Agenda Supplement

August 14, 2024
HDC Meeting

Objection to Proposal: 224, 228, 232 & 236 W Kingston Ave (Case No. HDCCMA 2023-00992)
Historic District Commission Hearing Date: August 14, 2024

Exhibit B²: The introduction of 2x density relative to existing and historic development has significant impact on the ignored rear contiguous lots that back up to the development site.

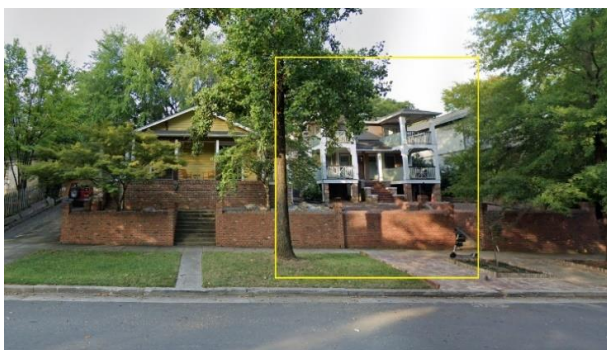
- There’s no reference to rear contiguous lots (243, 239, 235 and 231 W Park Ave) which are most directly impacted by crammed rear setback, rear balcony / window placement and taller construction of rear buildings (Buildings D, E, F), in turn removing significant privacy for these W Park Ave residence
